RE: Electric Owl Holdings, LLC: Petition to Amend the Code of the Village
Site: One South Broadway, Hastings-on-Hudson, New York

On behalf of Electric Owl Holdings, LLC (the "Applicant"), we respectfully submit this letter in response to comments from the Board of Trustees, including Trustee Morgen Fleisig and Trustee Douglass Alligood, regarding the project. This letter further supplements the Application and follows the most recent letters submitted on November 22, November 30, and December 4, 2023 by Cuddy & Feder LLP on behalf of Electric Owl Holdings, LLC (the "Supplemental Letters").

OVERALL SITE PLAN

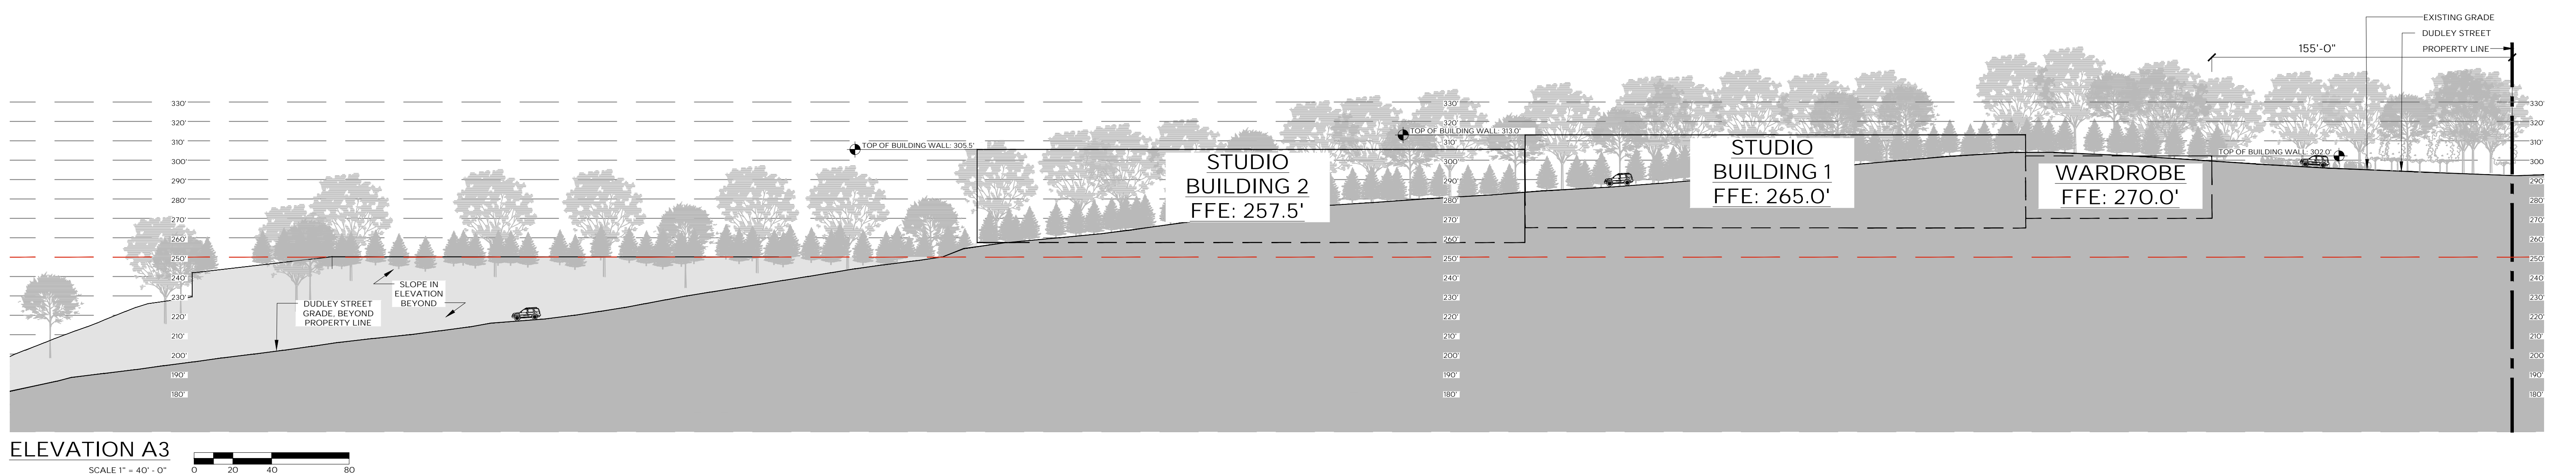
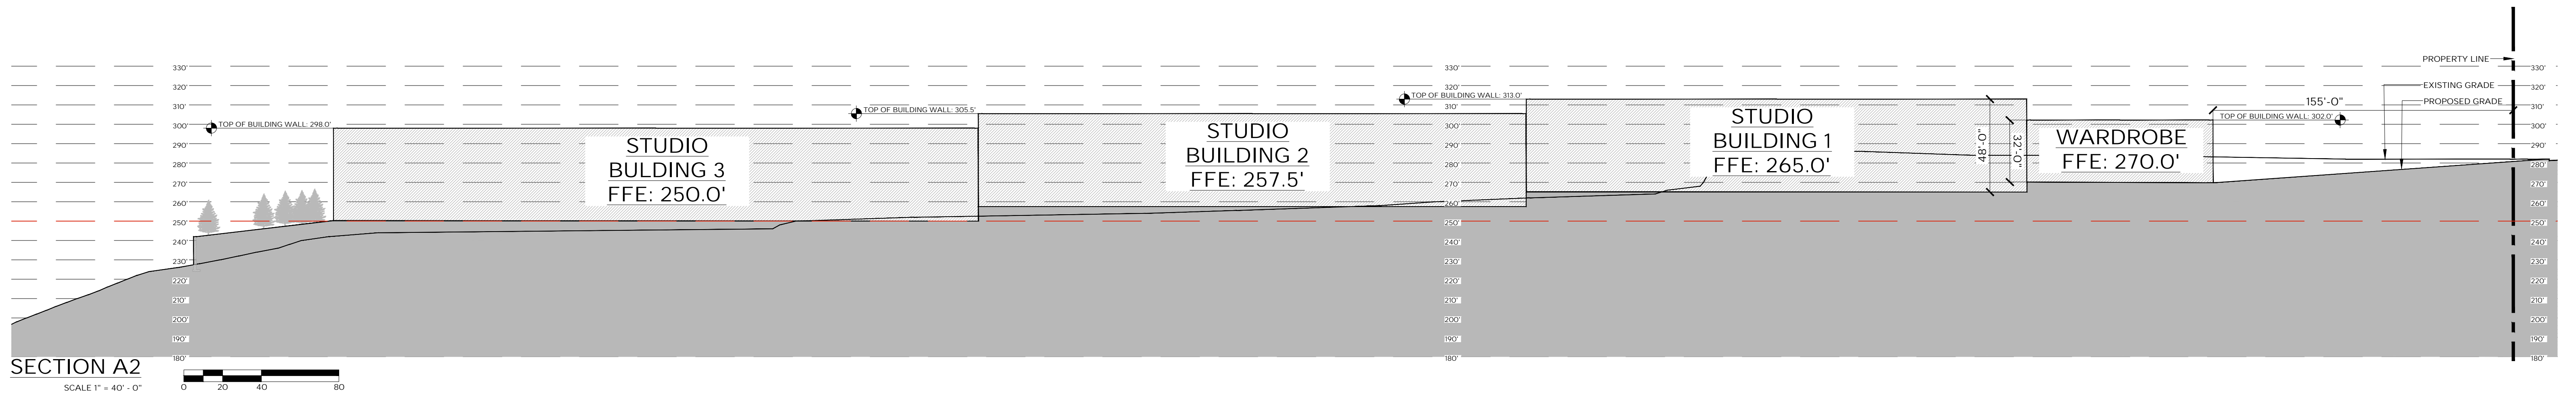
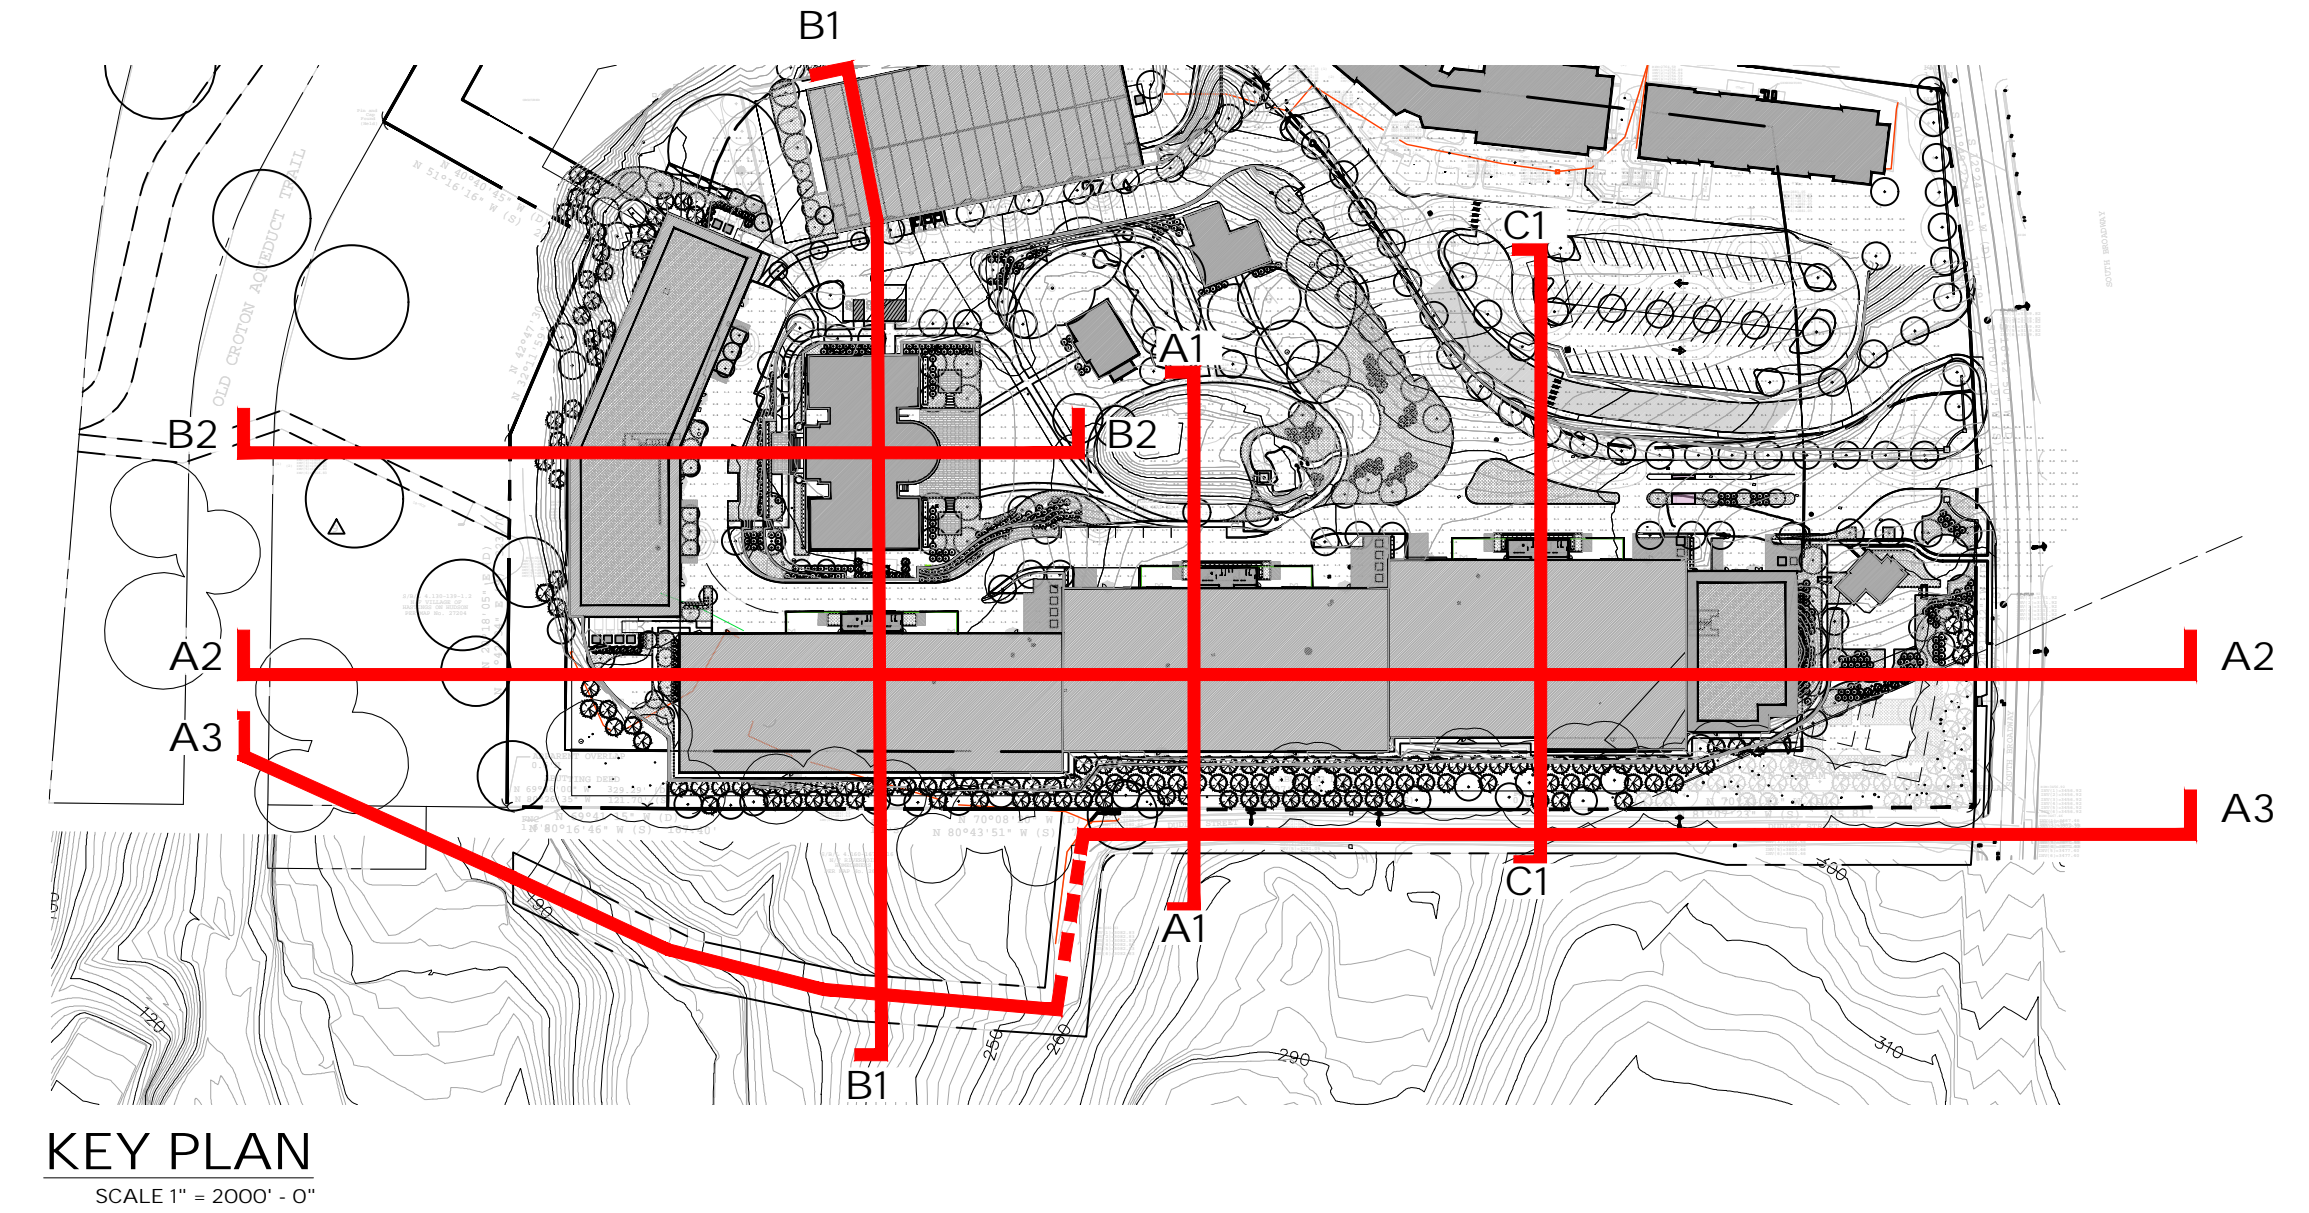
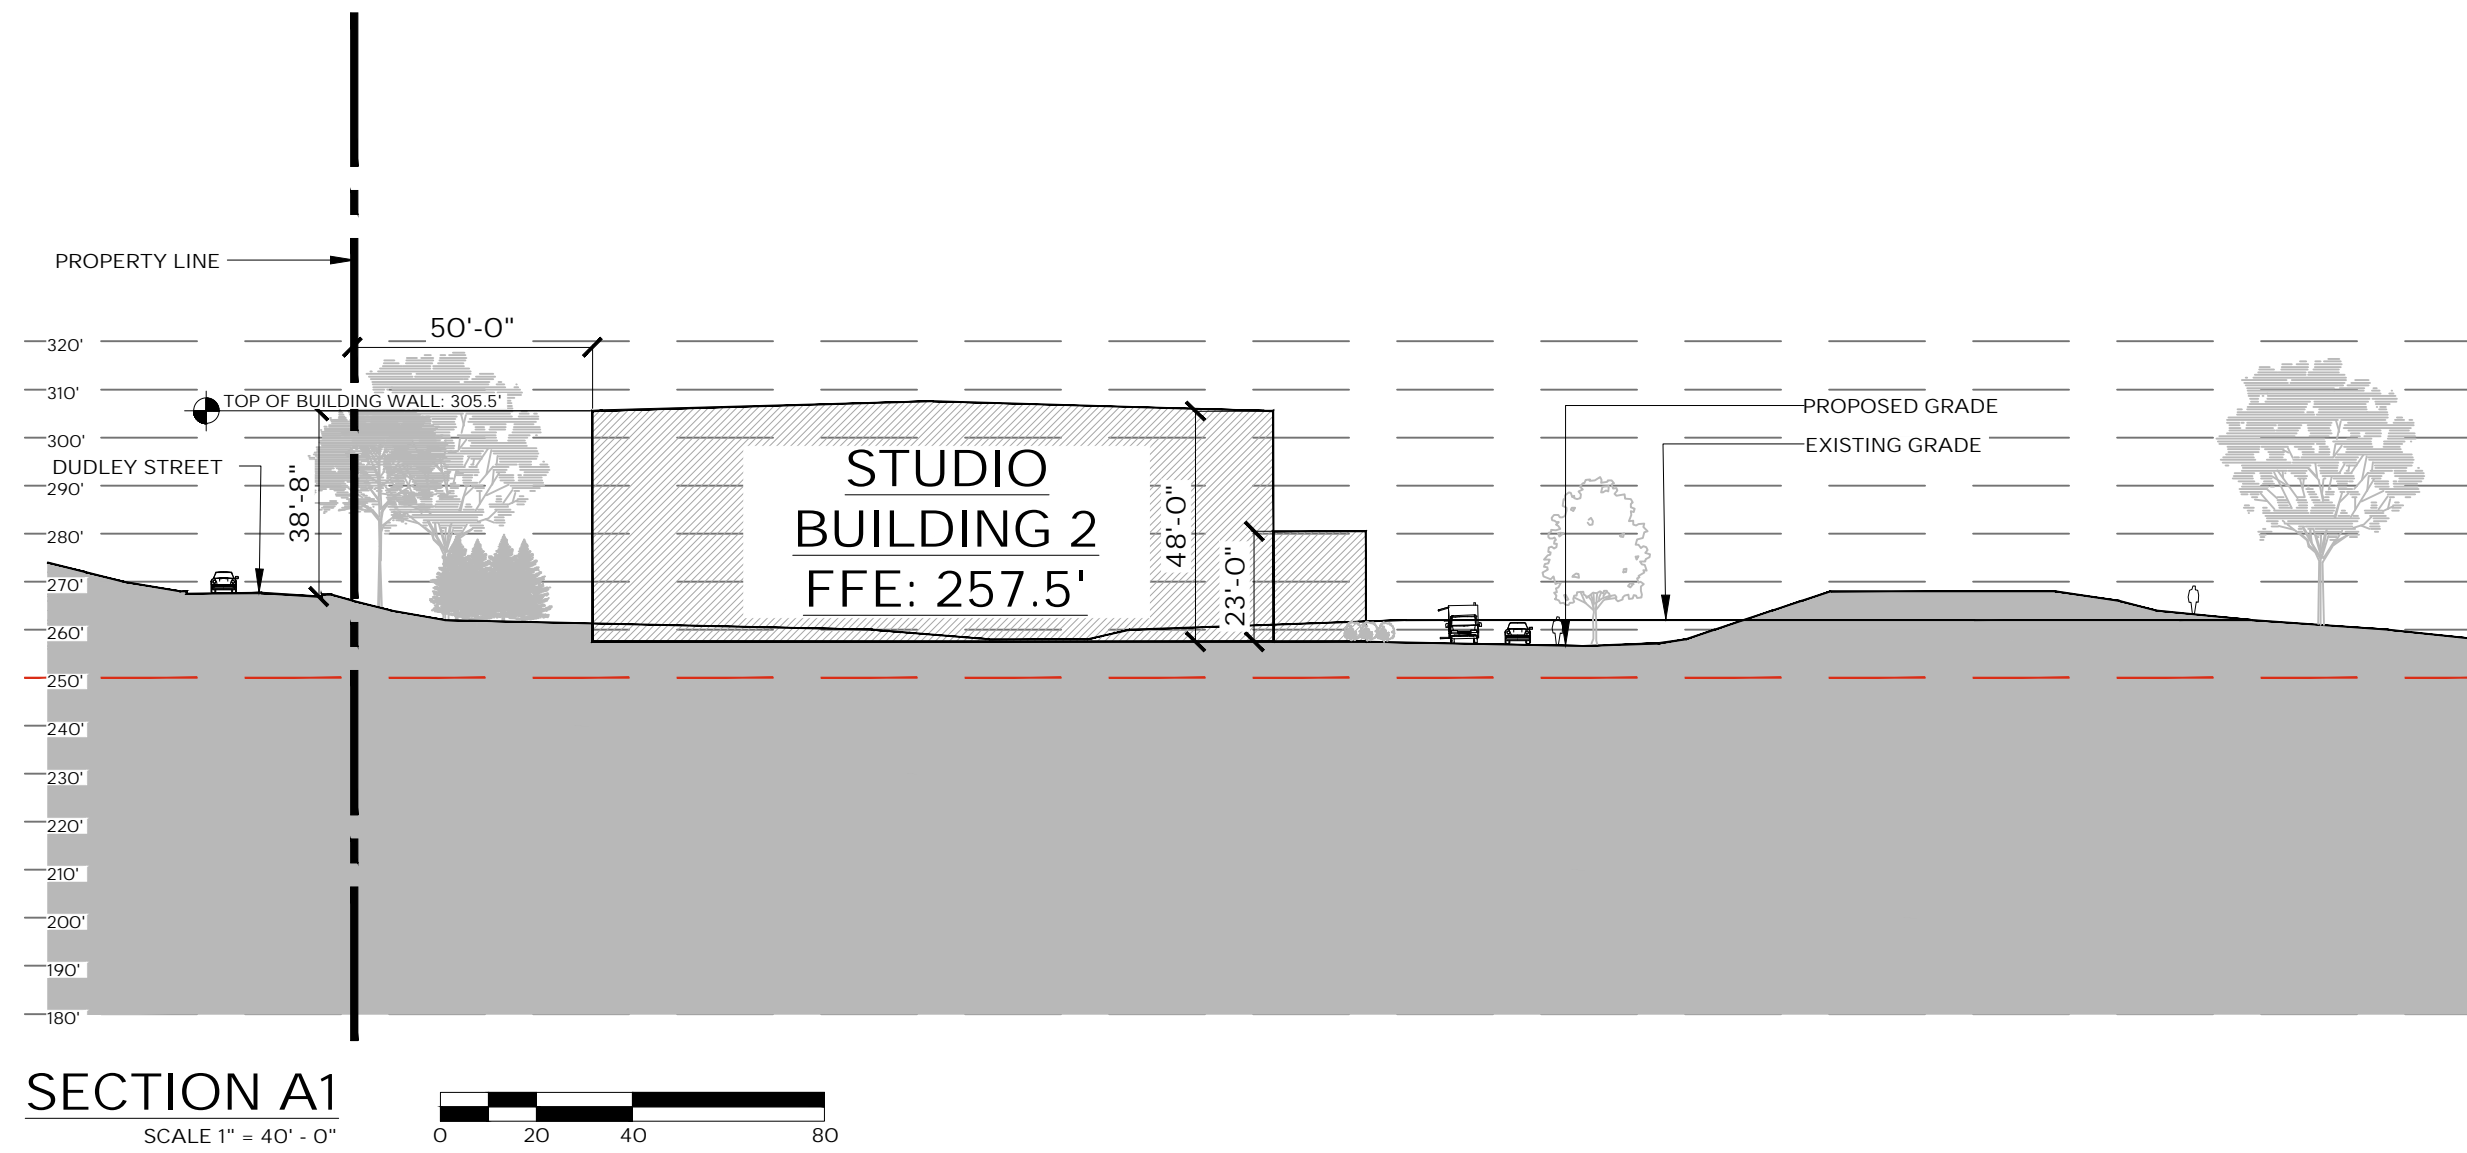
3. **Can a Site Plan be provided showing Fire Lane compliance, including grade elevations, hydrant locations, fire apparatus routes and staging locations and dimensions?**

4. **Can the Dimensional Requirements proposed for the Multimedia Production Studio Overlay District be calculated and clearly detailed showing Floor Area Ratio, etc.?**

Enclosed please find another version of the plan entitled, "Overall Site Plan," prepared by Kimley-Horn, which is annotated to show the details requested (the "**Fire Lane Compliance Plan**").

detailed on the Table annexed to the Fire Lane Compliance Plan. For ease of reference, a summary Table for the Studio lot is set forth below:
